# UNITED STATES PATENT AND TRADEMARK OFFICE

| APPLICATION NO. | FILING DATE | FIRST NAMED INVENTOR | ATTORNEY DOCKET NO. | CONFIRMATION NO. |
|-----------------|-------------|----------------------|---------------------|------------------|
| 10/582,434      | 06/09/2006  | Li Yadong            | D8888.0001          | 4874             |

| <b>Office Action Summary</b> | <b>Application No.</b><br>10/582,434 | <b>Applicant(s)</b><br>YADONG, LI |  |

## **DETAILED ACTION**

Fig. 23: Moriau et al. (US 6,490,836)

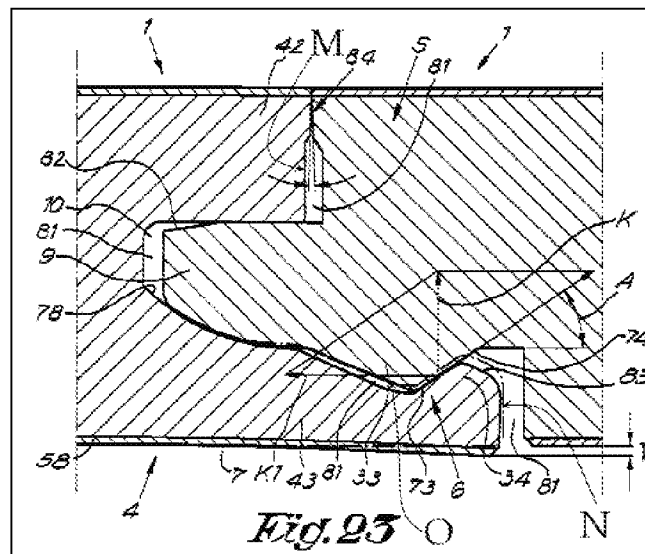
Moriau et al. further discloses the slot mortise (10) having a short end side wall (M) and an long end side wall (N); the upper surface of the slot mortise (10) being parallel to and having the same height with the upper surface of the tenon (9); characterized in that a V-shaped groove is provided in the lower surface of the slot mortise (10) and a corresponding convexity being provided on the lower surface of the tenon (9); the convexity, in the insertion direction of the tenon (9), has an anti-self-locking oblique surface (O) formed on its front end; the oblique surface (O) forms a first angle with the upper surface of the floorboard strip (1); a corresponding oblique surface (83) is formed on the external surface on the long end (lower side wall) of the slot mortise (10) to engage with the anti-self-locking oblique surface (O) (figs. 23-25); the rear end of the convexity matches perfectly with the external side surface of the V-shaped groove to form a self-locking surface, which forms a second angle with the upper surface of the strip; the second angle (A) ranges from 30-70°; and the external shape of the tenon (9) corresponds with the shape of the slot mortise (10) (fig. 23) (col. 10, lines 28-36).

Moriau et al. discloses the oblique surface (O) forms a first angle with the upper surface of the floorboard strip (1), but fails to disclose the first angle ranging from 15-35°.

However, Moriau et al. appears to disclose a first angle between 15-35°. Note the first angle is smaller to that of the second angle (A) which is disclosed to be in the range of 30-70°. Moriau et al. discloses the oblique surface (O) and corresponding

oblique surface (83) are angled to provide a smooth shifting of locking elements over one another (col. 12, lines 24-28),

Given the disclosure of Moriau et al., it would have been obvious matter of design choice to one of ordinary skill in the art at the time of the invention was made to have a first angle between 15-35° so as to provide a smooth shifting of locking elements over one another for ease of installation. No new or unpredictable results would be expected from having a first angle 15-35° as one of ordinary skill in the art would have discovered the optimum and workable ranges through routine experimentation. The floorboard piece of Moriau et al., which discloses the general conditions and structure of the claimed floorboard would be expected to perform equally well to that of applicants.
